mrcarpet
DESIGNS FOR FLOORS

29 Ashbury Road SW11 5UN

Wednesday, 8 August 2018

5 Issues Identified

Step/Riser to Bathroom

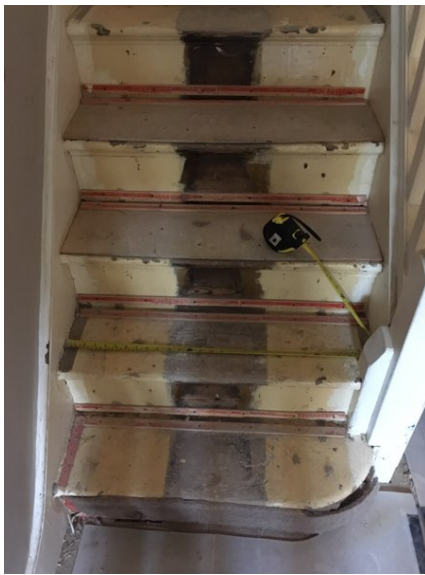
This section in my opinion would be more aesthetically pleasing if it was painted -but there would be sufficient carpet to cover it if required
